McLaren GTS - Bonnet Latch and Wheel Arch Liner Bracket Replacement

Bulletin type:	Campaign
Reference number:	N/A
Campaign reference:	SCB 22 A 002
Attention:	Retailer Aftersales Managers, Retailer Service Managers, Retailer Service Advisors, Retailer Technicians, Retailer Parts Managers
Affected vehicles:	McLaren GTS
Situation:	Replacement of the bonnet latch and wheel arch liner bracket
Procedure:	Action affected vehicles on first opportunity (immediately if already on site or during next Retailer visit if not already on site). Please refer to the information outlined in this document to complete the required work
Date:	30 th April 2025

Image 1: Overview of work area

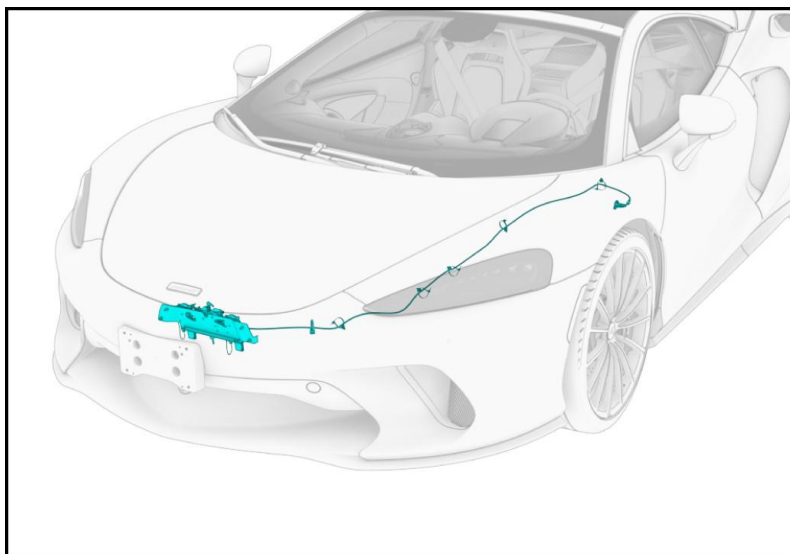
Through continuous product quality monitoring, McLaren Automotive has identified that in the instance of a flat 12V battery the manual operation of the bonnet opening may be inhibited on some McLaren GTS vehicles. To address this, McLaren Automotive has released an updated design of the latch for the bonnet and the bracket in the wheel arch liner.

Both actions, the replacement of the bonnet latch and wheel arch liner bracket, are required to be carried out to complete this Service Campaign.

Care Point: To complete the required work for this Service Campaign, you must replace the bonnet latch and release cable (together as supplied).
